# Notification of a Proposal to issue an Airworthiness Directive

**PAD No.: 23-106**

FB6 Double Burner Assembly

## ATA – Hot Air Balloon Burner Assembly and Hanger – Inspection / Modification

Figure 1 – Affected Part

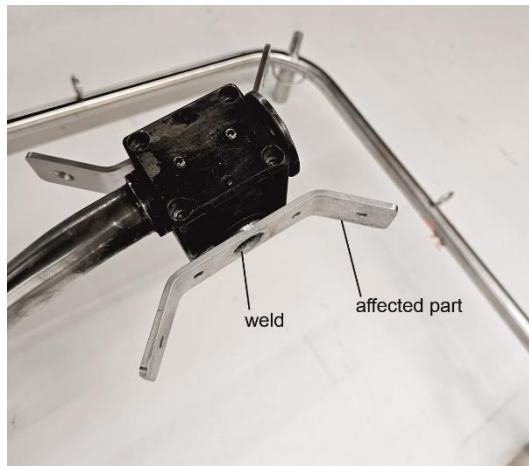
**Affected part:** Connector of FB6 double burner hanger, except a Serviceable part. See Appendix 1 to this AD.

An occurrence was reported of a burner type FB6 S/N 2.1239-1 where the connector between the burners was found detached during transportation, leaving one burner unit detached from the load frame. Investigation revealed that the welding process may have been improperly done, due to an insufficiently detailed description of that process in production. The suspected direct cause of failure is fatigue cracking of the weld, mainly due to improper handling during transportation.

- (1) Within 12 months or 100 flight hours (FH), whichever occurs first after the effective date of this AD, accomplish an inspection of the weld of each affected part, installed on a balloon, in accordance with the instructions of the TN.

- (2) If, during the inspection as required by paragraph (1) of this AD, any crack is detected or evidence of a weld with insufficient filler material is found, before next flight, replace the affected part with a serviceable part, in accordance with the instructions of the TN.

- (3) If, during the inspection as required by paragraph (1) of this AD, sufficient filler material, as defined in the TN, is found on an affected part, before next flight mark that part in accordance with the instructions of the TN.

- (4) From the effective date of this AD, do not install an affected part or burner assembly having the affected part installed on any balloon.
